PM21

Burnaston Parish Council considers that PM21 is unsound because the proposed link road has not been demonstrated to be necessary or justified, is not supported by an adequate assessment of reasonable alternatives and is not supported by sufficient evidence to demonstrate its effectiveness.

- Create Consultants STRA2 Access Strategy Review 2026

Burnaston Parish Council

Figure 1.1: STRA2 Indicative Masterplan Layout (source: SDDC)

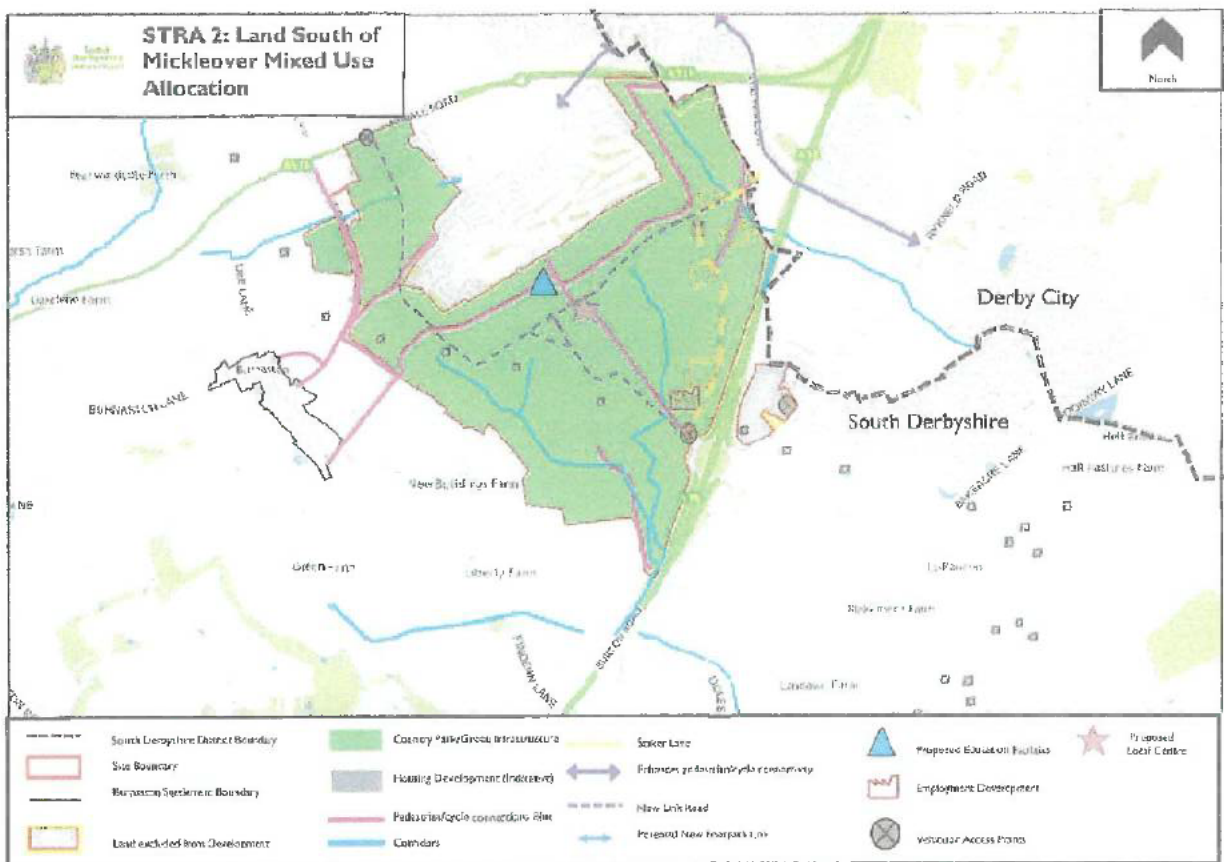
PM21 introduces a significant new transport intervention affecting the STRA2 allocation. The modification would result in the construction of a new transport corridor through land identified for Green Infrastructure, Country Park and settlement separation functions. It therefore has implications extending beyond transport matters alone.

The Council's stated justification for PM21 is that the Derby Housing Market Area transport modelling demonstrates that the link road is required to mitigate the impacts of development and support the wider transport network. However, the Parish Council's independent transport review prepared by Create Consulting¹ does not reach that conclusion. Create concludes that the available modelling does not demonstrate that a general traffic link between the A516 and A38 is required to facilitate the delivery of STRA2. In particular, Create identifies that the link road has not been tested in isolation, that the modelling combines multiple interventions within wider mitigation packages and that reasonable alternative access strategies have not been assessed. Consequently, whilst the Council relies upon the modelling as evidence that the road is required, the Parish Council considers that the modelling does not demonstrate the specific necessity of the proposed link road and therefore does not provide a sufficient evidential basis for PM21.

STRA 2: Land South of Mickleover Mixed Use Allocation

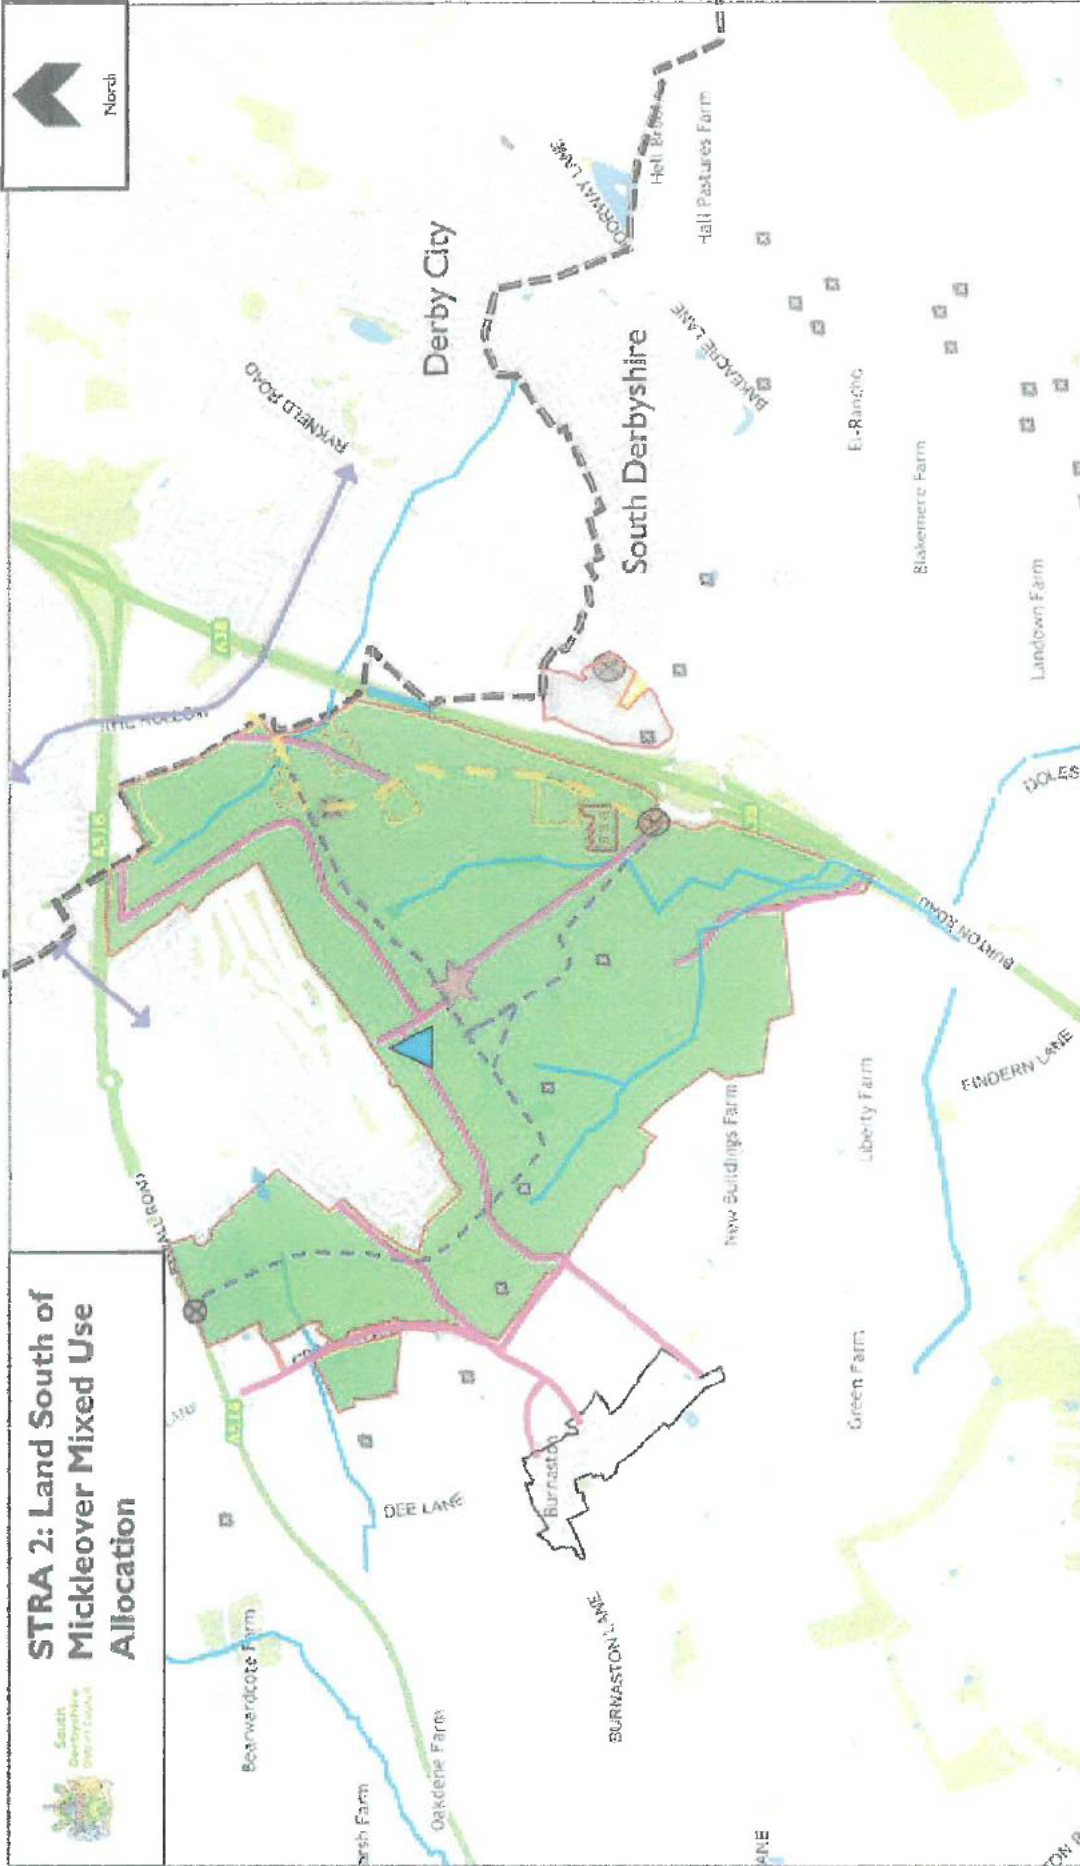
The PM22 Addendum Map (Appendix 2) does not provide sufficient clarity regarding a number of important features. In particular:

- the mapping does not explain the purpose and meaning of symbols shown on the plan, including the square symbols which consultees would reasonably expect to be both identified and broadly correspond with their position on the ground.
- the purpose and meaning of the blue corridor features are not clearly explained;
- the distinction between Country Park land, Green Infrastructure, formal recreation provision and retained separation land and development land is unclear; and
- important spatial relationships between existing residential properties, proposed infrastructure and surrounding land uses are difficult to interpret.

The Parish Council further notes that AM73 anticipates some more limited development fronting the A516. This appears to represent a material spatial change to the indicative distribution of development within the allocation. However, neither PM22 nor the supporting evidence clearly explains the planning rationale for this change. Consultees are unable to properly understand the implications of this element, including the scale, densities, extent or form of the development or understand how it relates to the wider Green Infrastructure and Country Park. This reduces certainty regarding the intended spatial structure of the allocation and makes it difficult to understand how the various components of STRA2 are intended to operate together.

Burnaston Parish Council requests that PM22 be amended to provide a revised indicative layout map and supporting explanation which clearly identifies the purpose, extent and intended function of the principal components of the STRA2 allocation.

- clearly distinguish between Country Park land, Green Infrastructure, retained separation land, formal recreation provision and development land;
- clearly explain the purpose and function of all symbols, corridors and annotations shown on the plan;

- correct the red site boundary line to clearly identify existing residential properties and their relationship to surrounding land uses, proposed infrastructure and formal recreation provision;

- clearly explain the extent, purpose and relationship of any development proposed along the A516 frontage to the wider allocation strategy;
- provide sufficient information to enable consultees to understand how the various components of STRA2 are intended to operate together; and
